RE: **Utility Trailer Sales**
8201 Daytona Rd NW
Grading Plan Stamp Date: 4/30/18
Drainage Report Stamp Date: 4/30/18
Hydrology File: K09D026B

DRAINAGE AND TRANSPORTATION INFORMATION SHEET (REV 10/2015)

**RE: UTILITY TRAILER SALES
8201 DAYTONA RD NW
GRADING AND DRAINAGE PLAN
ENGINEERS STAMP DATE: 3/27/18
HYDROLOGY FILE: K09D026B**

ENGINEER'S SEAL	UTILITY TRAILER SALES ALBUQUURQUE NM	DRAWN BY LA
		DATE 4/20/2018
	GRADING AND DRAINAGE PLAN	2017041—GRADING
	VINCENT P. CARRICA P.E. #16212	 <i>TIERRA WEST, LLC</i> 5571 MIDWAY PARK PLACE NE ALBUQUERQUE, NM 87109 (505) 858-3100 www.tierrawestllc.com
		JOB # 2017041

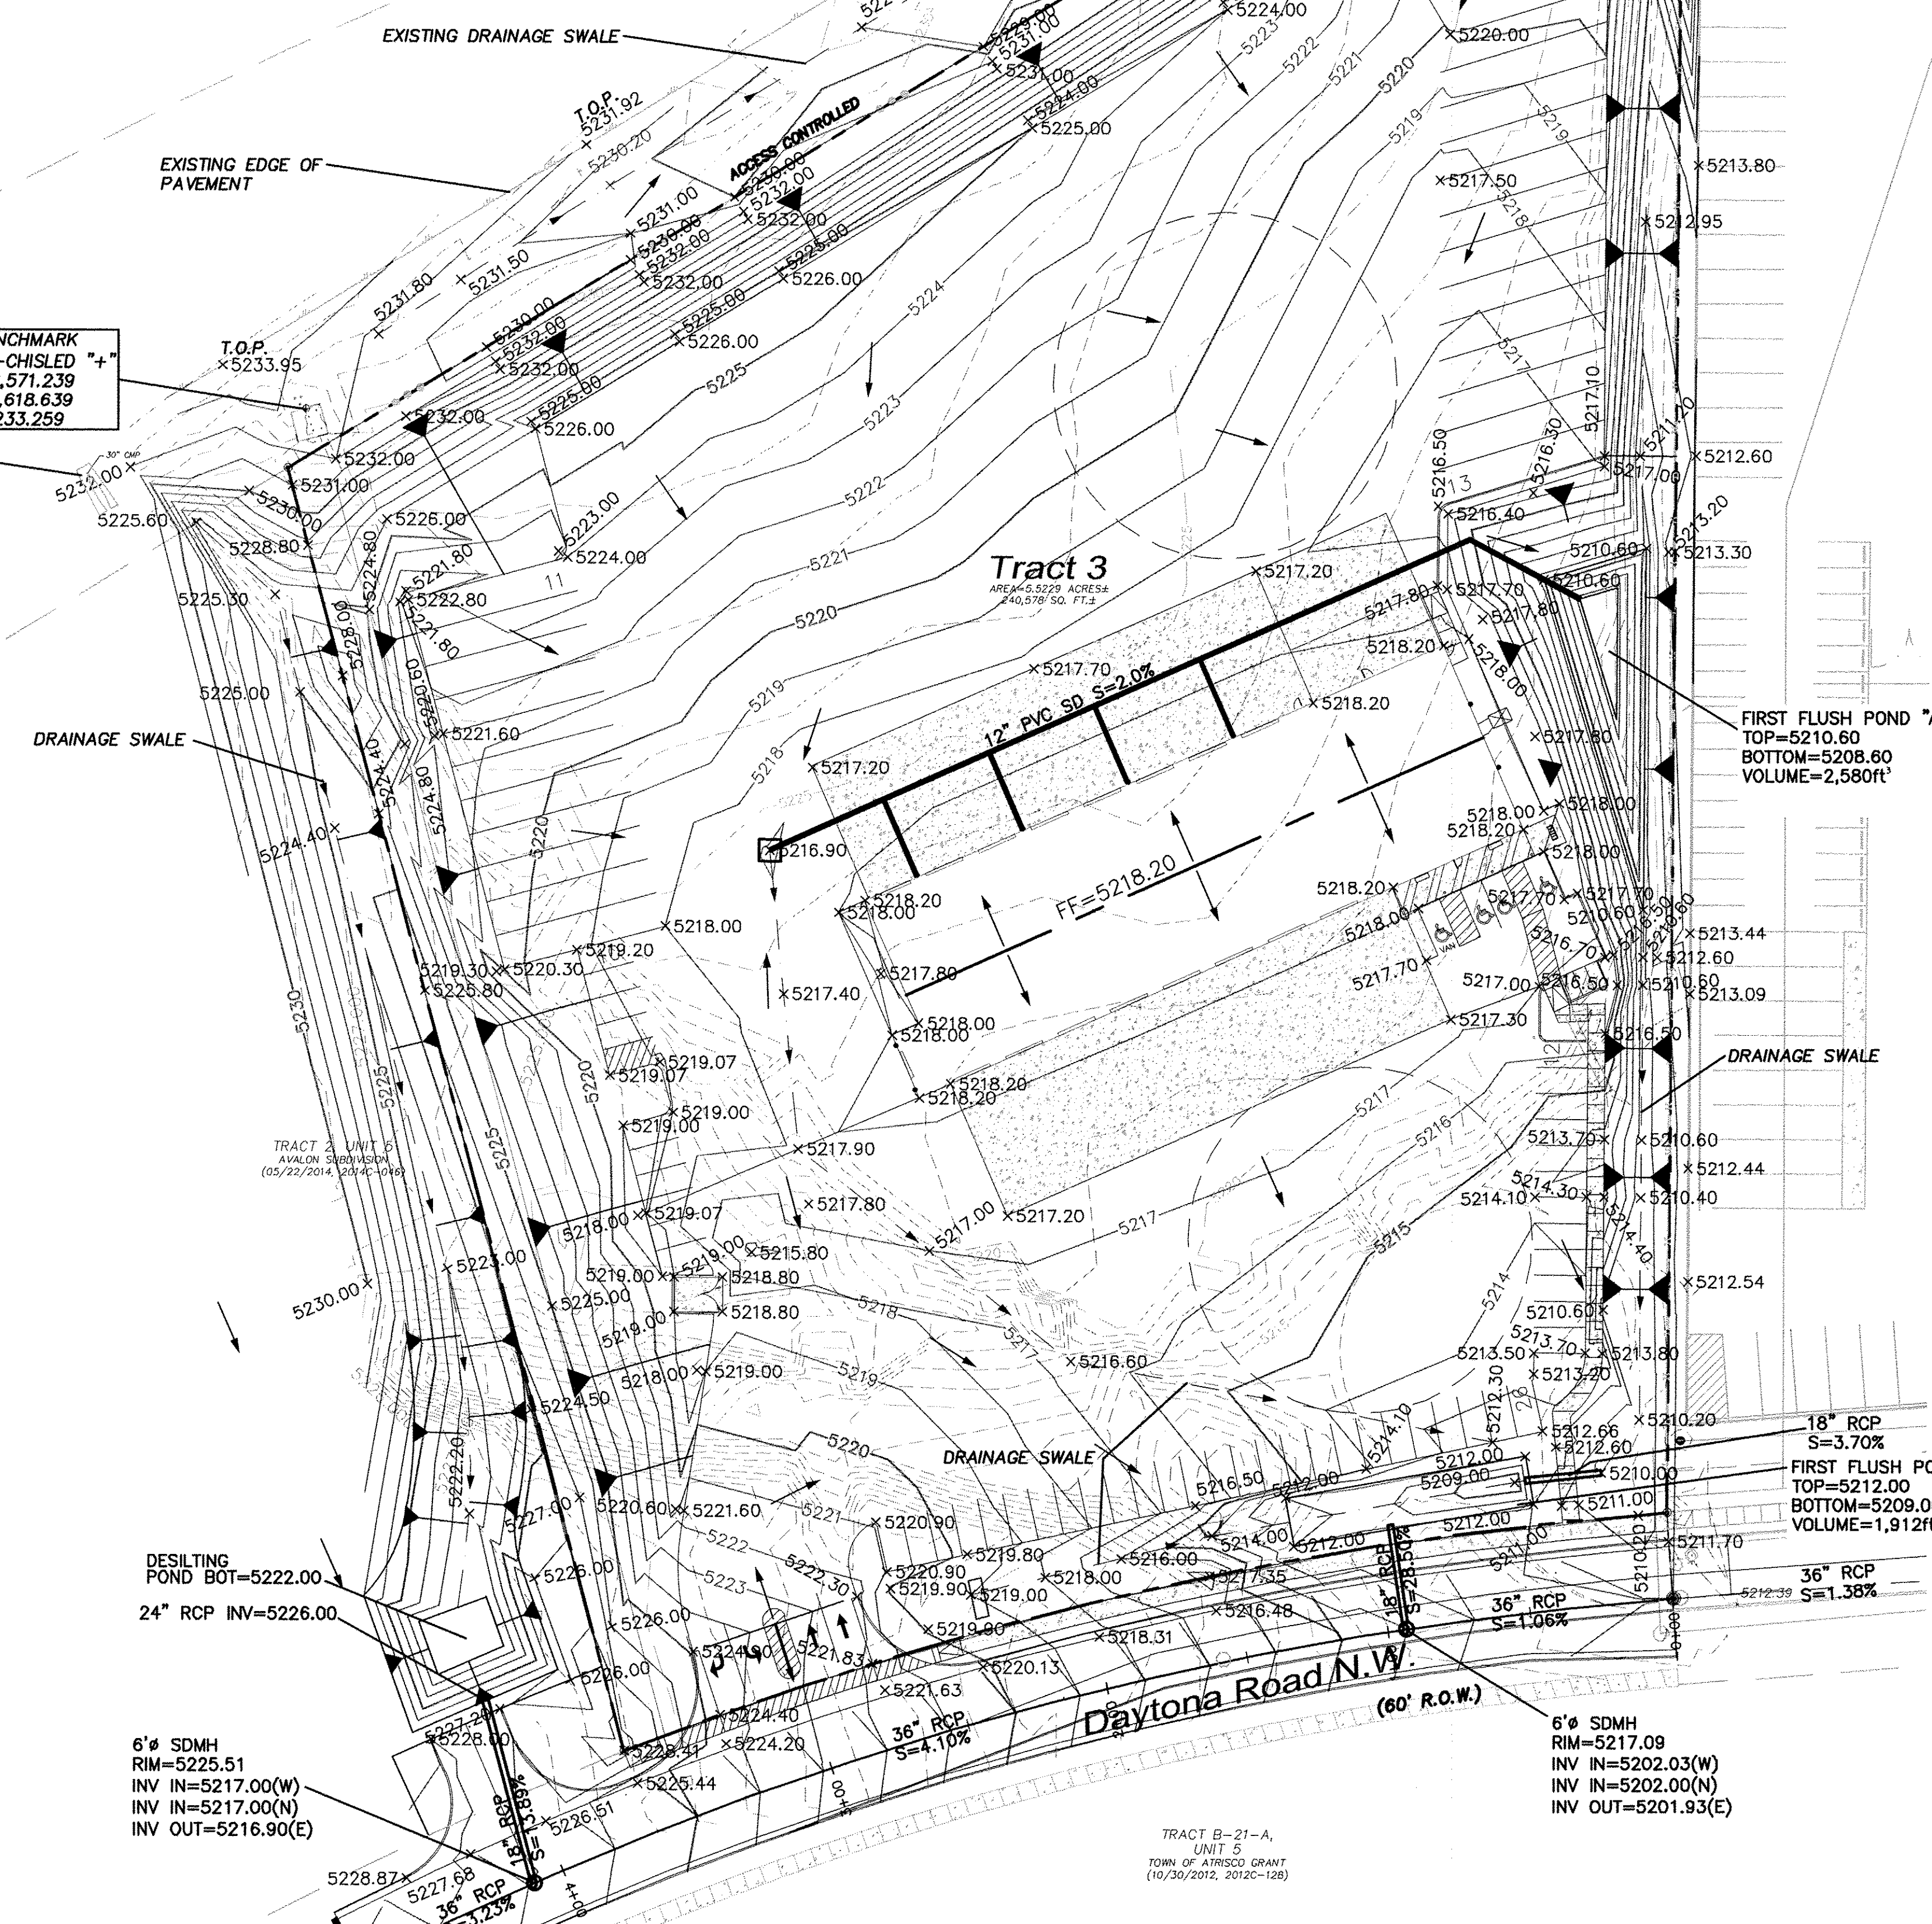
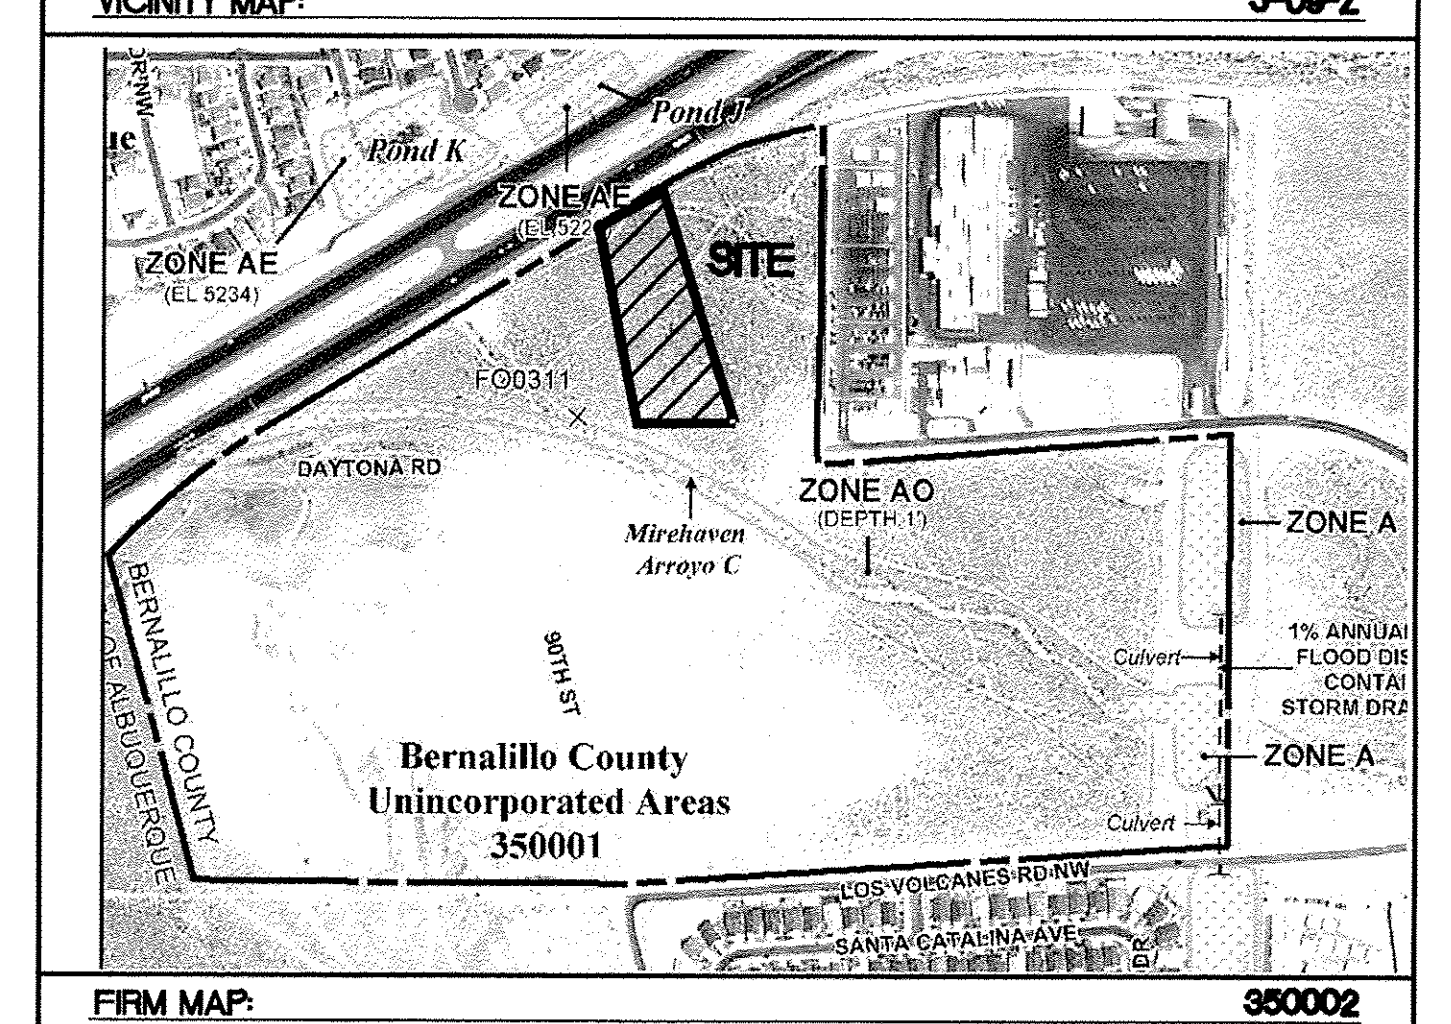
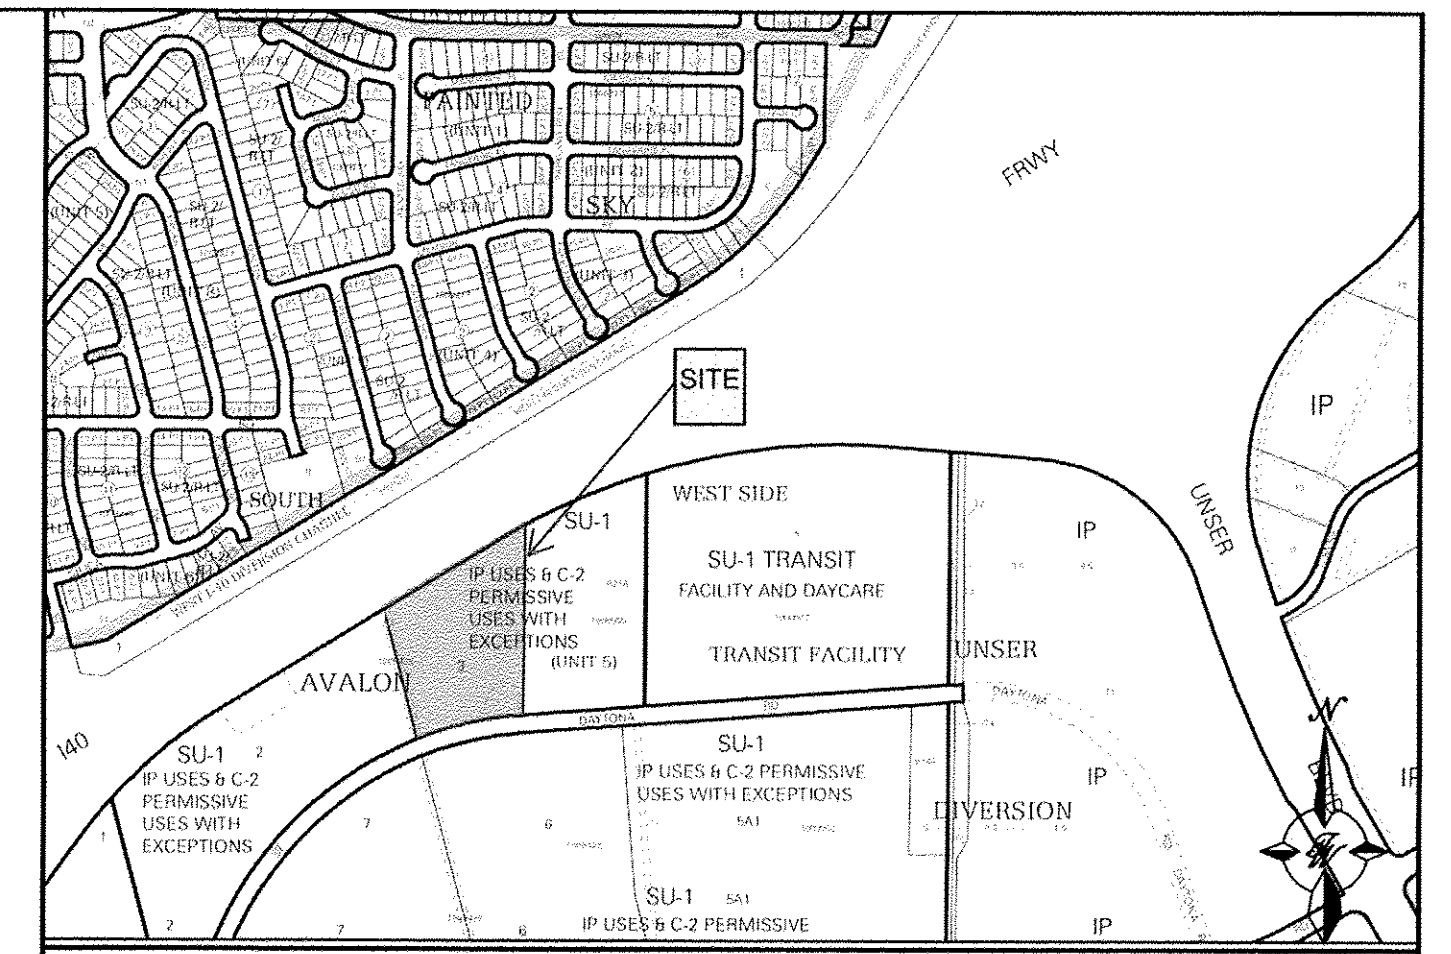
1. There may be a need for additional inlets in Daytona to contain future developed flows in the street. Provide street capacity analysis in Daytona. You may assume the subject site as discharging directly into the storm drain as you've proposed; however the upstream contributing basins will need to be assumed as discharging to the street.

2. Include inlet protection for the two new RCP stubouts to keep floatables and sediment from washing into the storm drain (ported riser or similar).
3. Provide written permission from the adjoining property (Tract 2) for work on their property. A public drainage easement and an agreement and covenant are required for the maintenance of the realigned swale and the pond, as these facilities convey public water.

4. Provide a public drainage easement and an agreement and covenant for the riprap and gabions in the NE corner.
5. Include project datum.
6. This grading plan includes existing and proposed contours and spot elevations showing regrading of the I-40 bar ditch and grading at both median drain outfalls. Provide written concurrence from NMDOT D3 Drainage that this project can proceed. All work in NMDOT's ROW will need to be included on the infrastructure list.

7. The upstream offsite basins need to be delineated and included in your analysis. Demonstrate that the diversion swales are adequately sized to convey these flows from the I-40 ROW to the receiving storm drain along Daytona.
